**Environmental Assessment of
Ground Water Compliance at the
Shiprock Uranium Mill Tailings Site**

Final

September 2001

Prepared by
U.S. Department of Energy
Grand Junction Office
Grand Junction, Colorado

Figure 2. Physiographic Block Diagram of the Shiprock Site

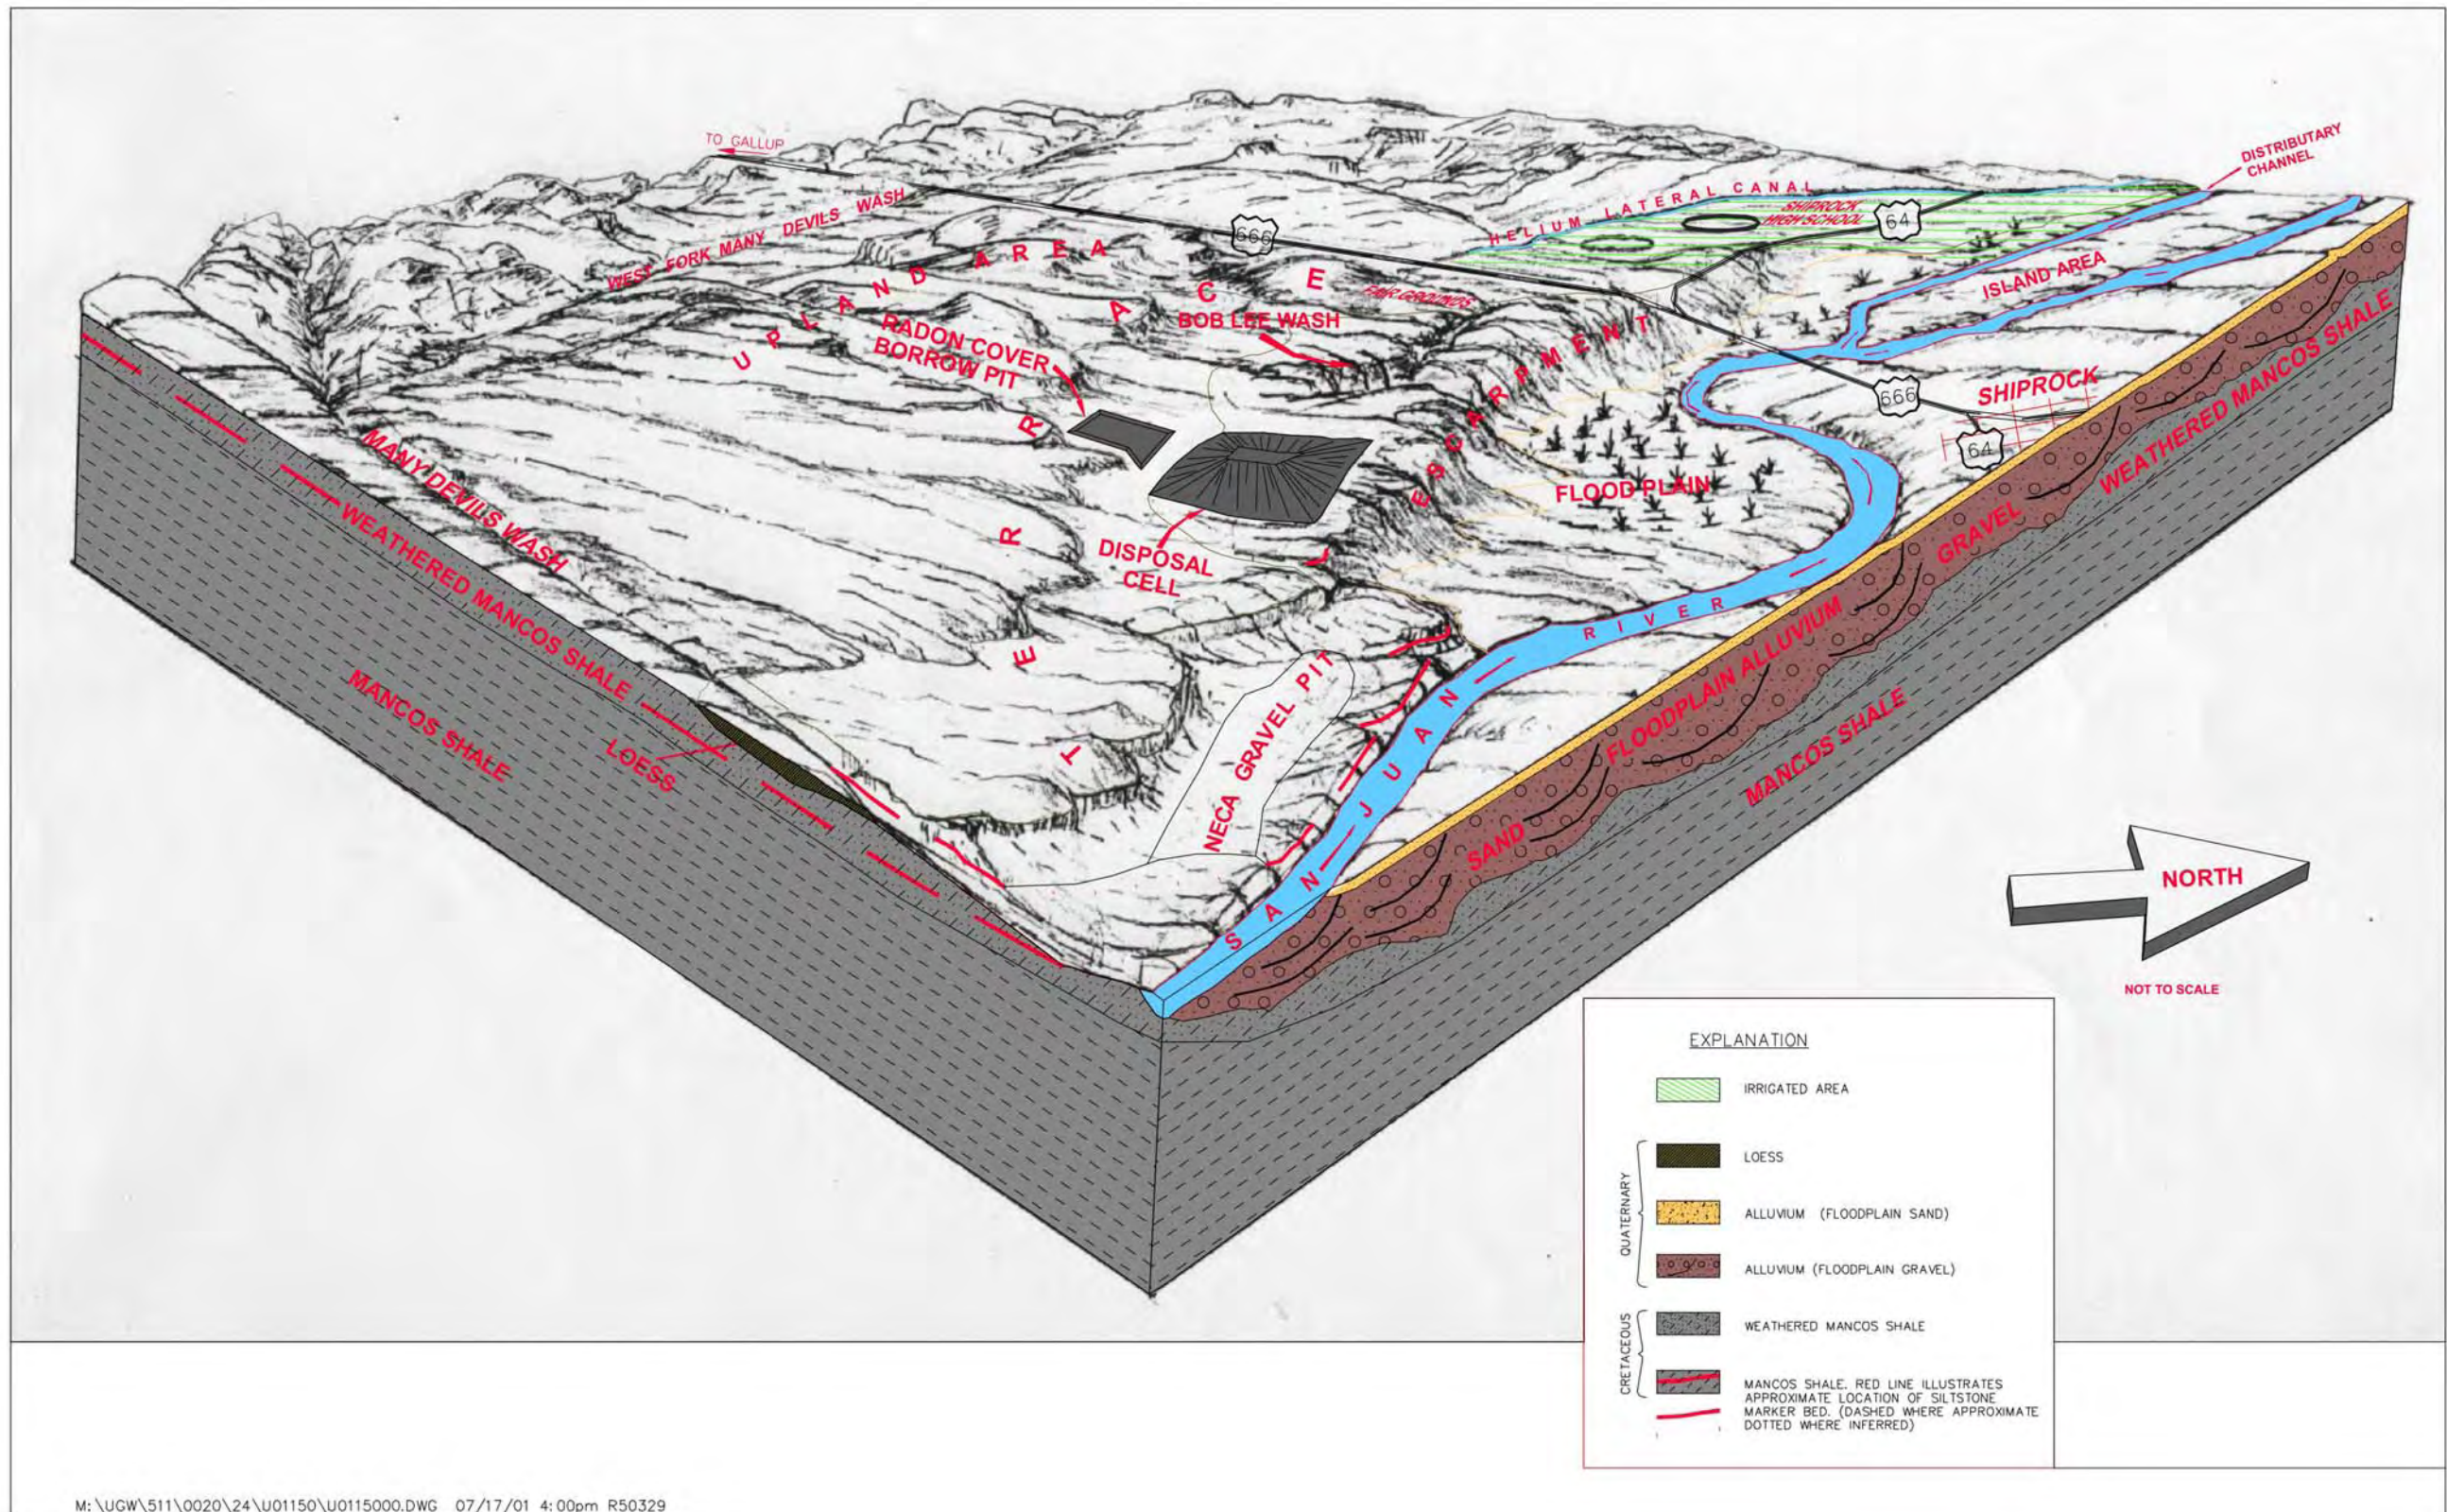
EA Comments ^a		Issue Type ^b	Status ^c	Response/Resolution
89	p.5, Figure 2: The map may not be to scale, but the cross-section showing the geologic features should be somewhat realistic. Alluvial sediments generally do not lie flat when deposited; rather, the stream profile should indicate the flow characteristics from channeling caused by erosion and deposition.	T	A	Some bedding surfaces will be added to Figure 2 in an attempt to show the channeling in the alluvial material.
90	p. 6: There is no page 6.	S	NC	Page 6 is the back of page 5. All color figures are printed separately on a color printer. Running the figures through again to print the even page numbers on the reverse side would add considerable time and expense to the preparation of the report. Also, if pages with color figures are used for two-sided printing, the text tends to burn through onto the figure.
91	p.7, Figure 3: Change caption to “Looking Southeast from Northwest.”	T	A	The caption will be changed.

Figure 5. Ground Water Compliance Selection Framework for the Terrace East Area

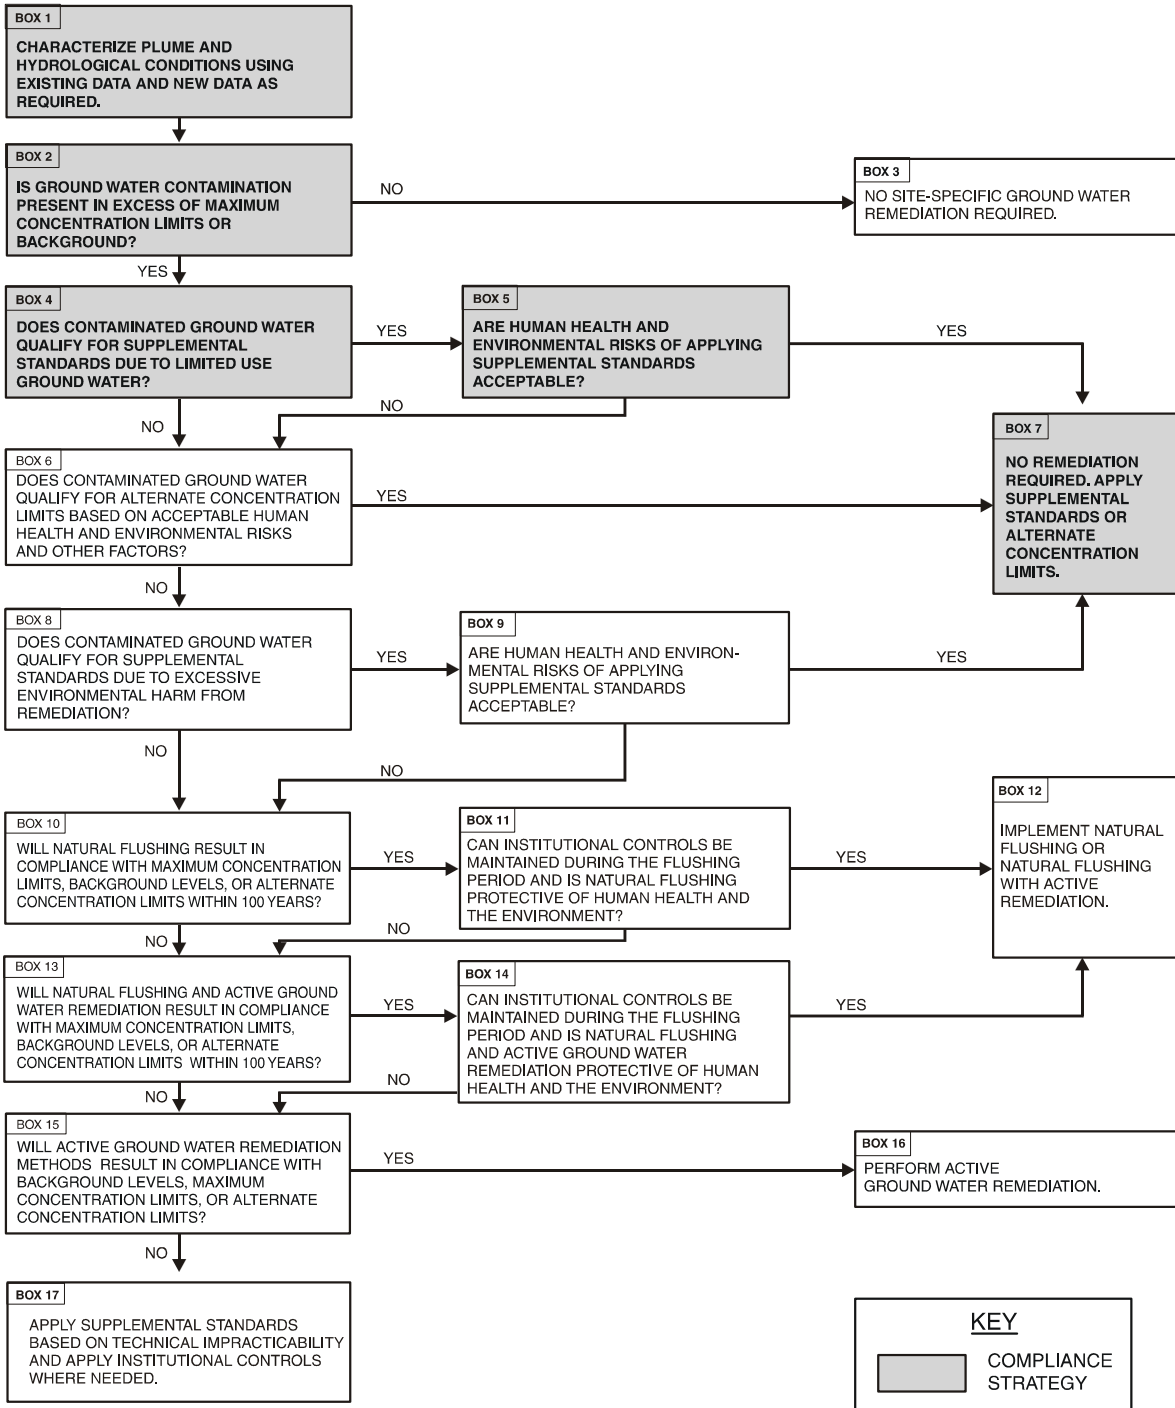
46	Figure 5: The same symbol (*) references two different notes, making this figure confusing unless both notes are supposed to be referenced each time.	S	A	Agree. This will be changed in the EA. Remove the “* Strategy will be reevaluated if conditions change or if monitoring indicates that EPA standards will not be met.”

Figure 22. Wetland and Vegetation Locations at the Shiprock Site

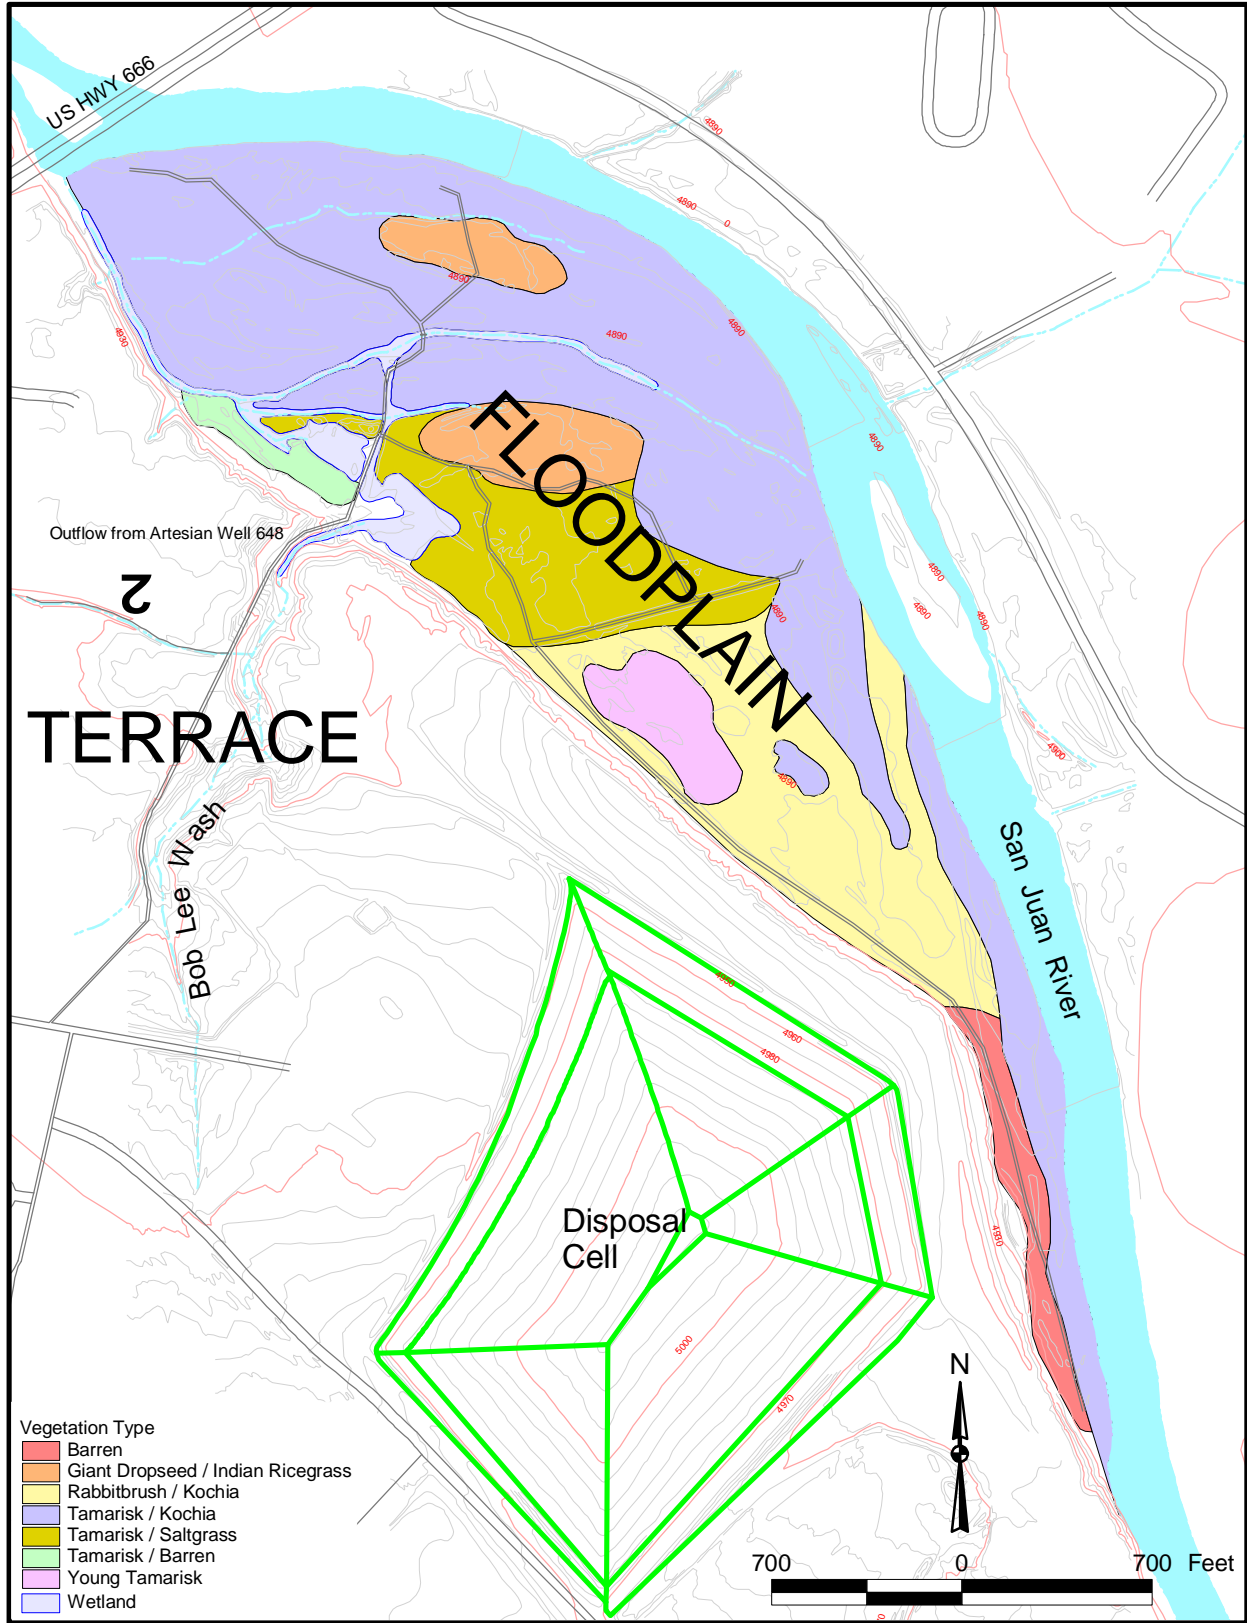
62	Sec. 4.3.1, para. 1, p.53: It is unclear whether Bob Lee Wash would be considered part of terrace east, but portions of that wash other than those delineated in EA Figure 22 would likely be considered jurisdictional wetlands, in contrast to the statement made in this paragraph.	R	NC	The jurisdictional wetlands was delineated in accordance with Corps of Engineers criteria. Due to potential conflicts with historical grazing rights, DOE has suggested to Navajo regulatory agencies that the wetlands be provided protected status if the Navajo Nation wishes to promote wetland values. To date a final response has not been received.
63	Sec. 4.4.2, Terrace West Area, p.71: Is the water clean enough for people to eat food such as beans, leaf lettuce, or fruit from an orchard (without washing first) if those plants have been watered with a sprinkler irrigation system? What if the yield is sufficient for agricultural uses in the highly contaminated portions along the east side of terrace west? Any water that may be used for irrigation or watering of food crops will need to meet standards similar to drinking water standards.	T,R	A	Concentrations of selenium are high enough in terrace west ground water that they could accumulate in certain types of plants to levels that are higher than recommended for dietary intakes of some animal species. Selenium is the constituent present in terrace west ground water that has the greatest potential for bioaccumulation. Selenium is an essential nutrient for humans, though it can be toxic at higher than dietary levels. Selenium uptake by plants and fruits is highly variable and it is impossible to say, in the absence of site-specific and plant-specific data, whether the ground water is safe for irrigation use. It is recommended that some other source of irrigation water be used for watering food crops.

Figure 24. Sample Locations for the Salt Deposit Study

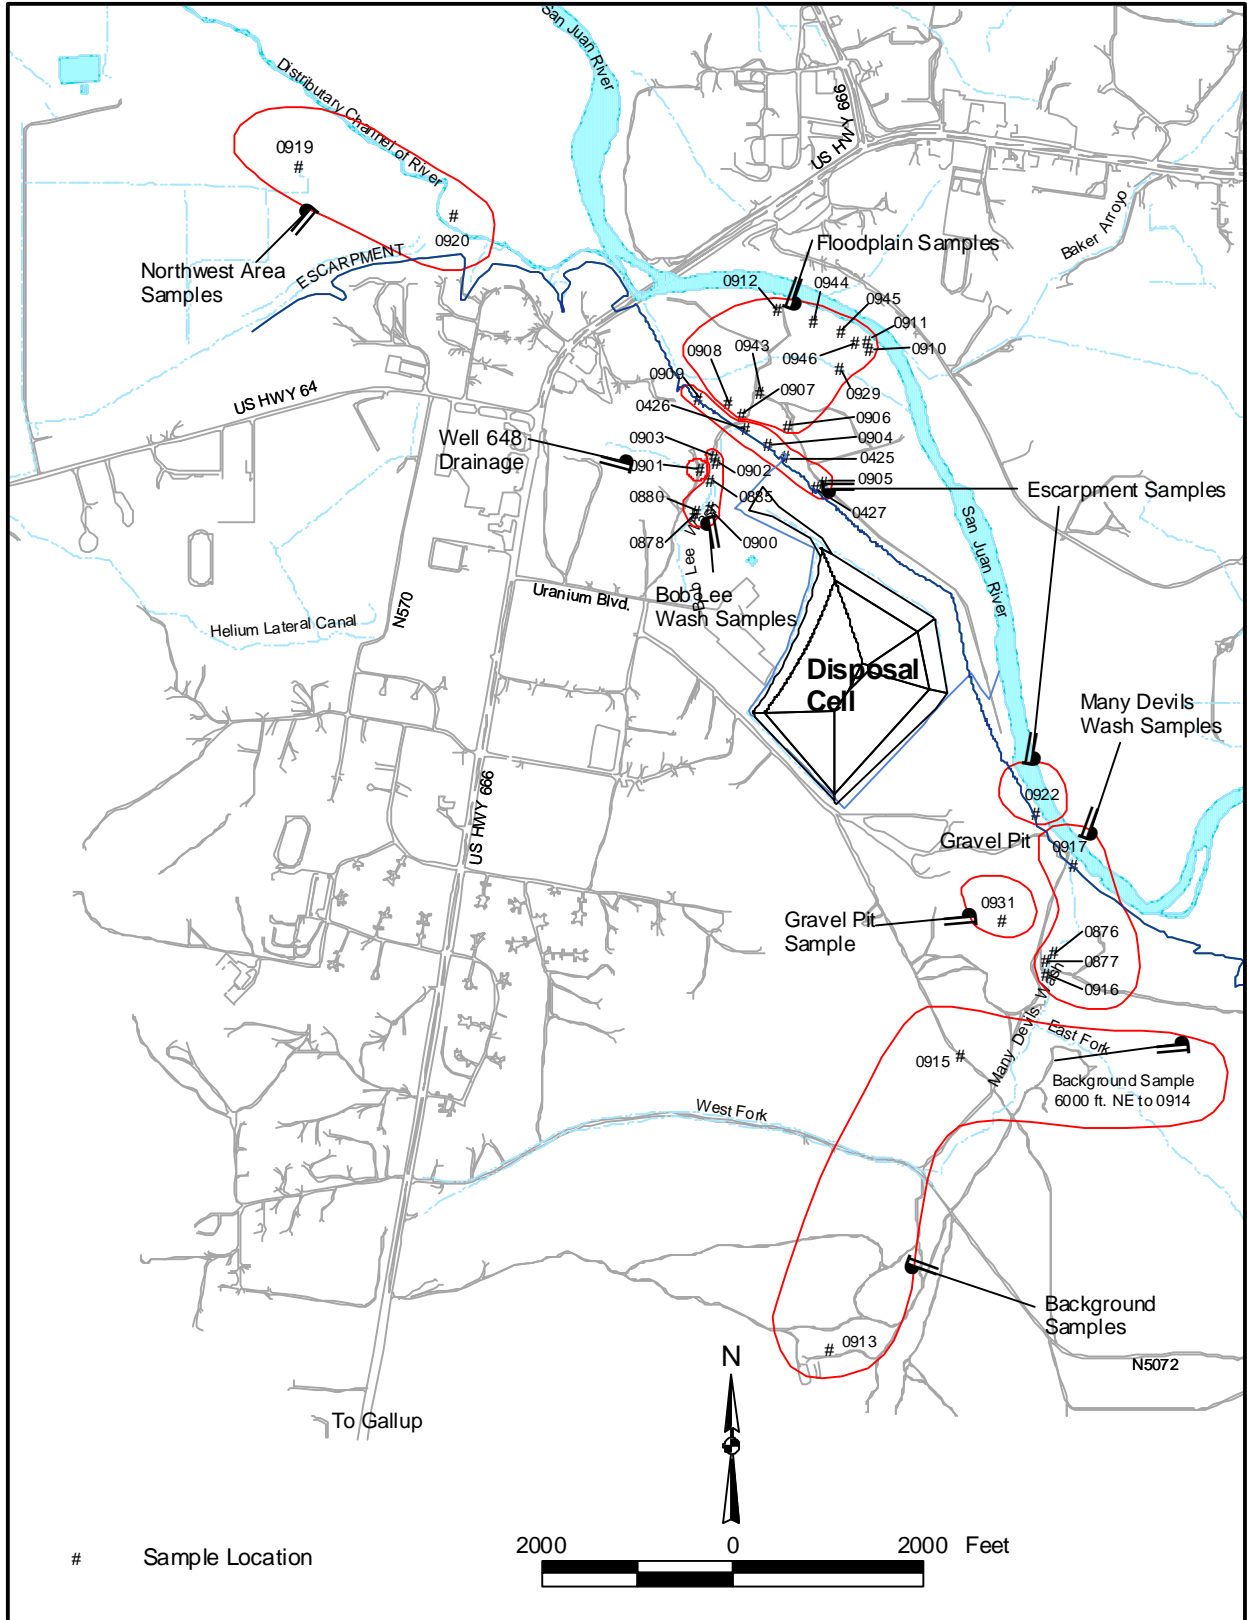
110	p.59, Figure 24: Remove the text "US HWY 66" on the northern highway.	S	A	Figure 24 will be revised.
111	p.80: "Dr. Steve Semken" should probably be written as "Steve Semken, Ph.D."	S	A	Revision will be made.
<i>U.S. Fish and Wildlife Service comments received June 14, 2001</i>				
112	The Service cannot concur with DOE's conclusion that the proposed remedial actions "may affect but are not likely to adversely affect" federally listed species.	R	NC	DOE acknowledges the Navajo Fish and Wildlife and U.S. Fish and Wildlife Service concerns and is committed to working with both agencies to address protection of endangered species. DOE believes that remediation will have a positive effect on endangered species.
113	The Service would like to meet...to continue informal consultation on the project.	R	NC	Since the receipt of comments on the EA, DOE has communicated with the USFWS and Navajo Fish and Wildlife on several issues that still require resolution. DOE has agreed to continue consultation as the project progresses and has committed to determining if additional short-term actions in specific areas require mitigation beyond that already completed as interim actions.
